MEMORANDUM

To: Mr. Christian Krahforst, Director, Climate Adaptation and Conservation
Town of Hull, Massachusetts

Date: January 18, 2024

Re: 51 Harborview Road NOI Peer Review

Figure 9: Plan View of Proposed Alternatives

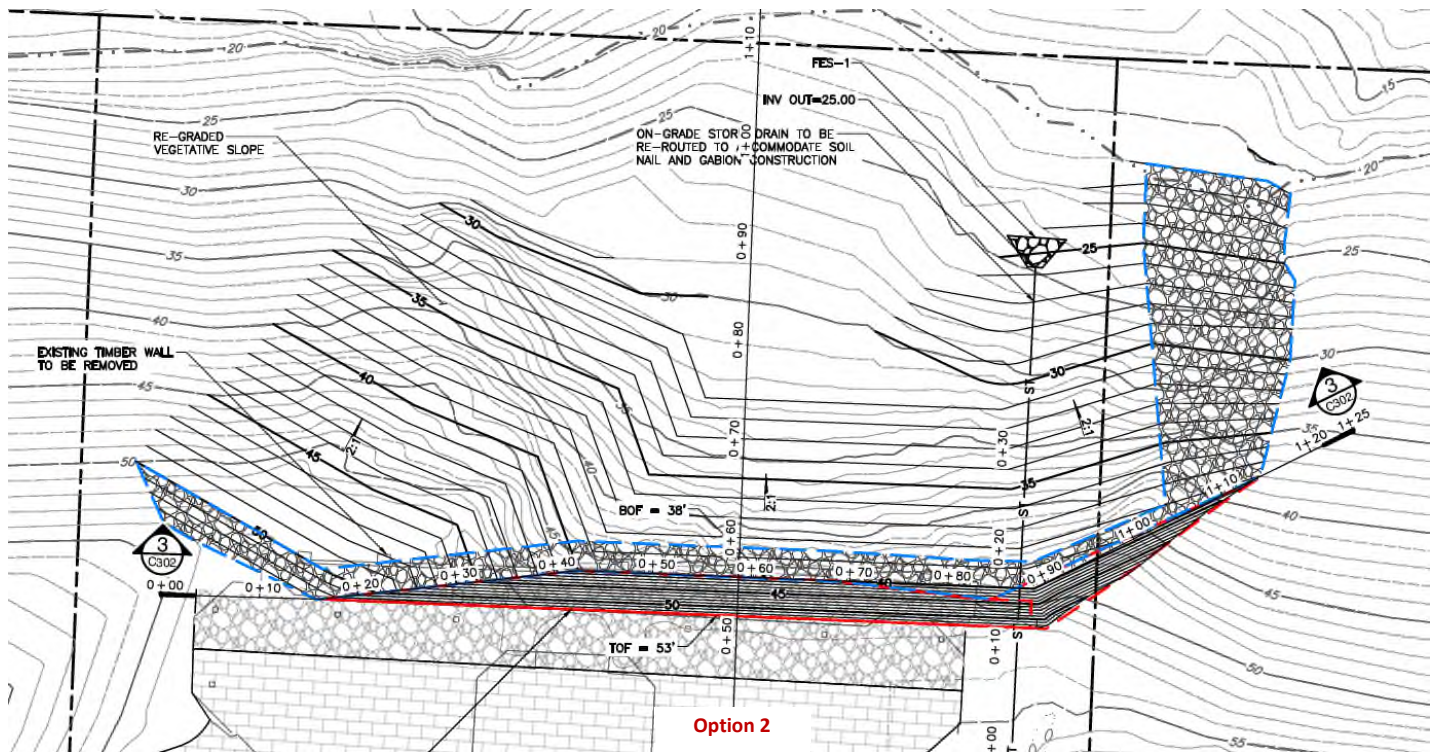
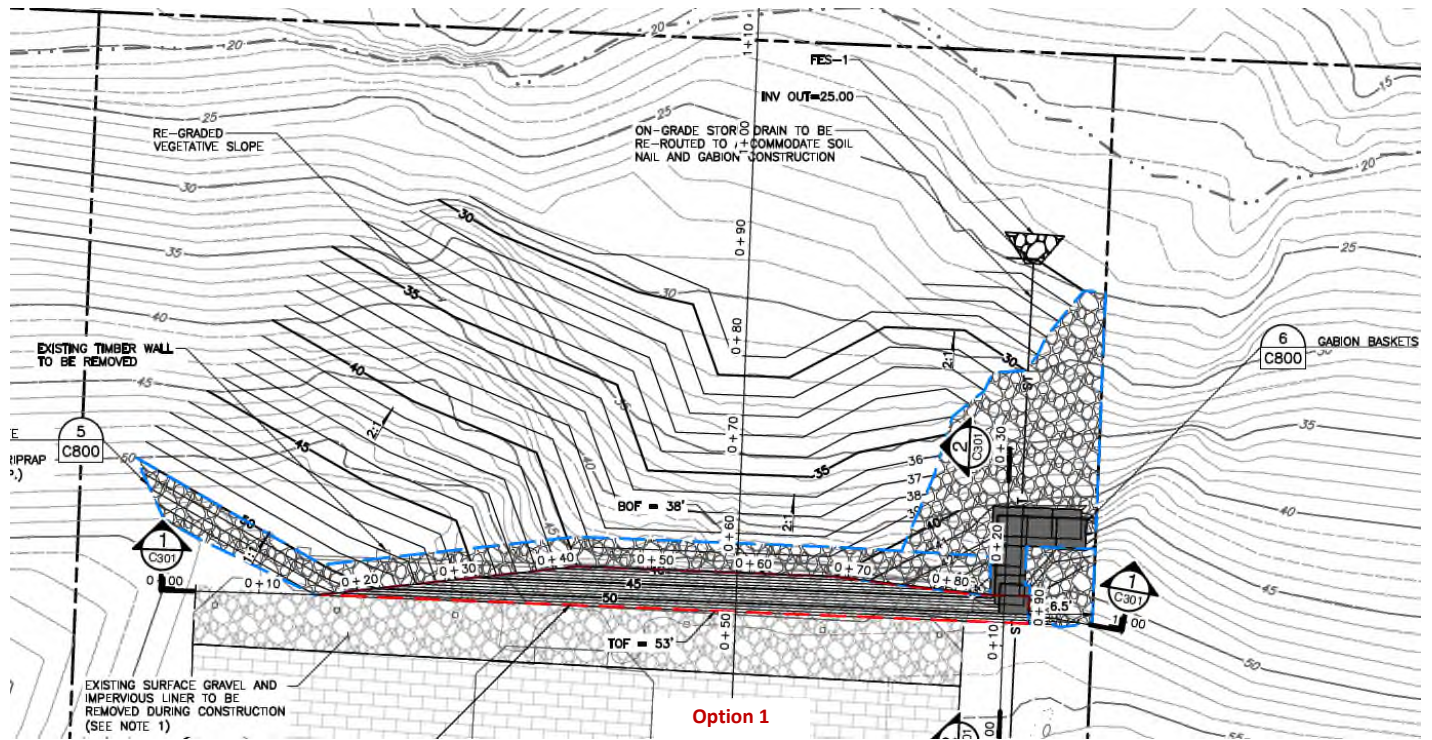
- Two different slope repair options were presented (**Figure 9**):
 - #1: Soil nail wall with gabion baskets and riprap slope ending at the property line between 51 and 53 Harborview. Gabion baskets were proposed to provide slope stabilization at the property line, where the proposed grades do not smoothly tie into the grades on the abutter property at 53 Harborview.

- #2: Soil nail wall with riprap only (no gabion baskets) extending beyond the property line such that the scarp on the property of 53 Harborview is filled in with riprap stones.

- The proposed wall is able to achieve a factor of safety of 1.67 for a rotational type of slope failure, along the selected representative section.
- The gabion basket section did not meet the minimum factor of safety requirements (1.5) in all directions. In our opinion, the results are conservative as they were based on 2-dimensional analysis, whereas the gabion basket section is essentially a 3-dimensional structure. However, we suggest that a wider wall system be considered to

achieve the minimum factors of safety against stability failure. The design did not provide details relative to the gabion wall such as basket layout, sizes, subgrade mitigation, or backfill requirements.

Figure 10: Typical Cross Section of Proposed Soil Nail Wall

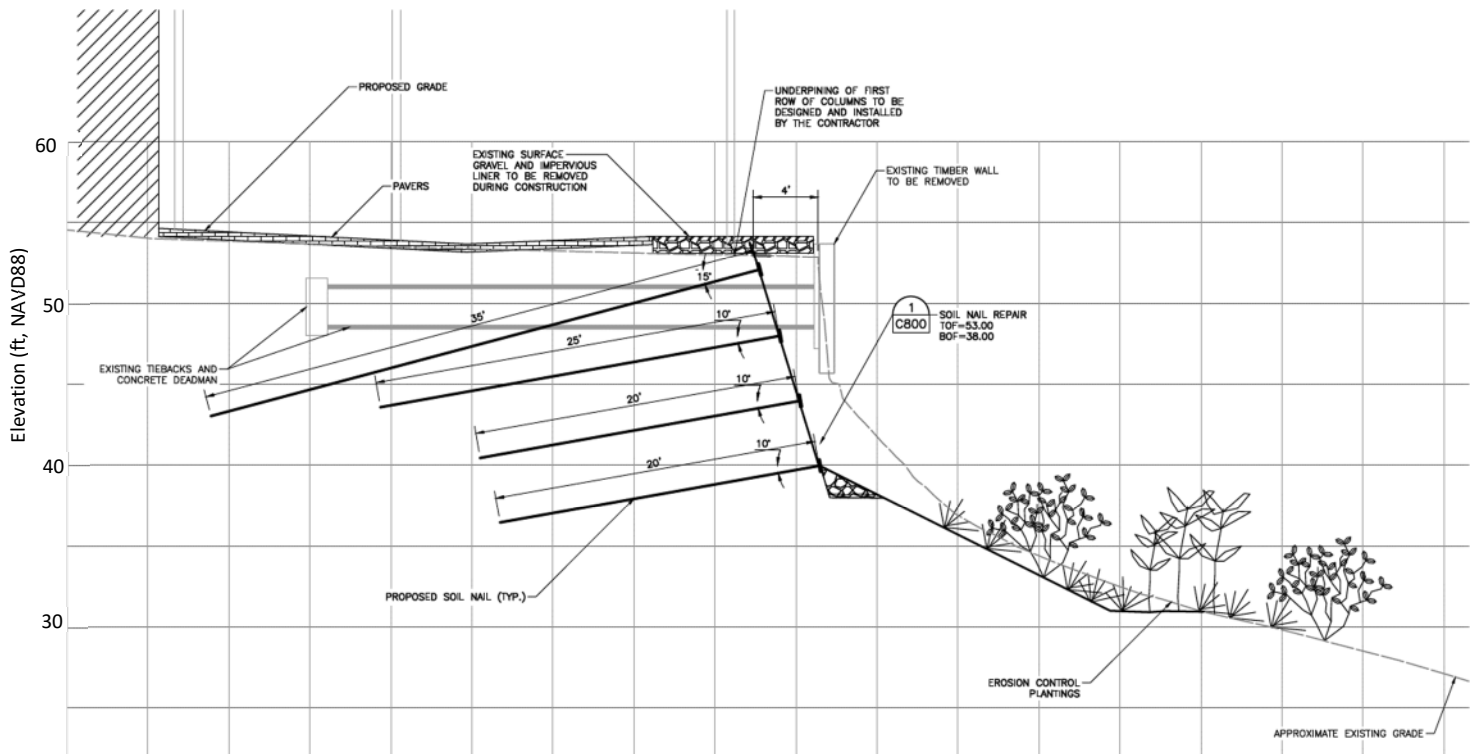
- Geometries used for the analysis/calculations were verified and checked using the existing topographic information. The soil nail wall is approximately 14 feet in height, between El. 54' and El. 40'. Four rows of soil nails were proposed, at a 4' x 4' (vertical and horizontal) spacing. **Figure 10** presents a typical cross section of the soil nail wall developed by CEC, including the stone patio at the top and revegetation area at the toe.

- Soil (geotechnical) material properties such as frictional angle and cohesion values used were judged reasonable. Surcharge loads from the existing deck structure were included. First row of deck column will be underpinned and the third row of columns next to the house are included in the surcharge that represents the loads from the existing building. The elimination of the deck loads from the first (northern most) row of deck columns may not be fully represented of the driving forces on the soil nail wall. The type of underpinning will influence impacts on the wall stability. The type of underpinning should be provided.

- Groundwater effects¹⁰ were evaluated per CEC's sensitivity analysis results by assuming a groundwater table at Elevation 29.3 feet NAVD88 which exists at Elevation 20 feet NAVD88 at the toe. The assumed groundwater table intersected with the slope failure plane in the back analysis (Ref. 11, Attachment 3); the groundwater table did not intersect with the failure block in the soil nail wall design analysis (Ref. 11, Attachment 4).

- The drainage strips specified appeared to be standard practice for soil nail construction, for constructability reasons. A constant, high flow of groundwater through the strips is not expected, in view of the generally low groundwater table at the Site.

- The proposed design should incorporate a method to limit seepage migrating to the proposed wall within the previously installed anchor trenches below the patio.¹¹

- The proposed design should incorporate a method to capture runoff from the patio area and divert away from the new wall.
- Design drawings (plan and section views) should include the existing granite block wall. At the failed section/design cross section, GZA recommends that the existing granite block wall (beyond the failed cross section) be shown in the background (e.g., in gray/dash), for visual references and additional information. The failed section needs to be restored as part of this project, to fully align with the sections on both sides. See additional comments section below.

Figure 11: Example of Perched Groundwater Table/Wetting Front Line

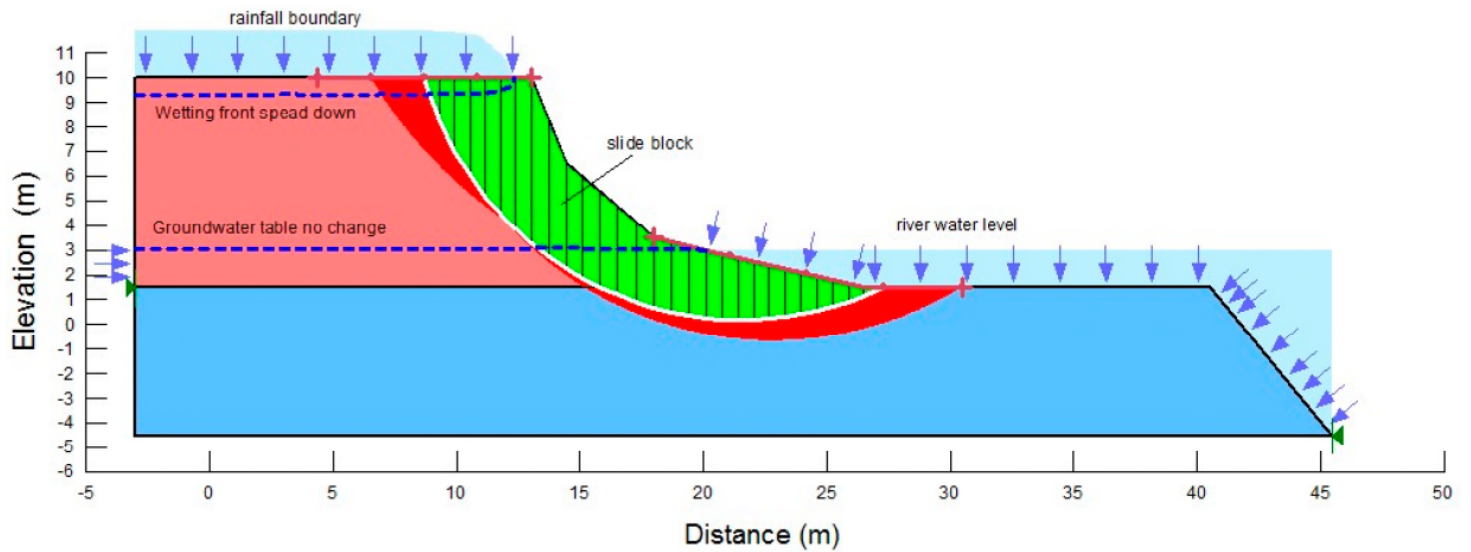
- Perched groundwater table (i.e., wetting front) due to heavy rain infiltration below the patio area (in addition to the main phreatic surface line) is highly recommended to be evaluated in the SLIDE model (see example in **Figure 11**) as a sensitivity check. Transient seepage modeling will be required.
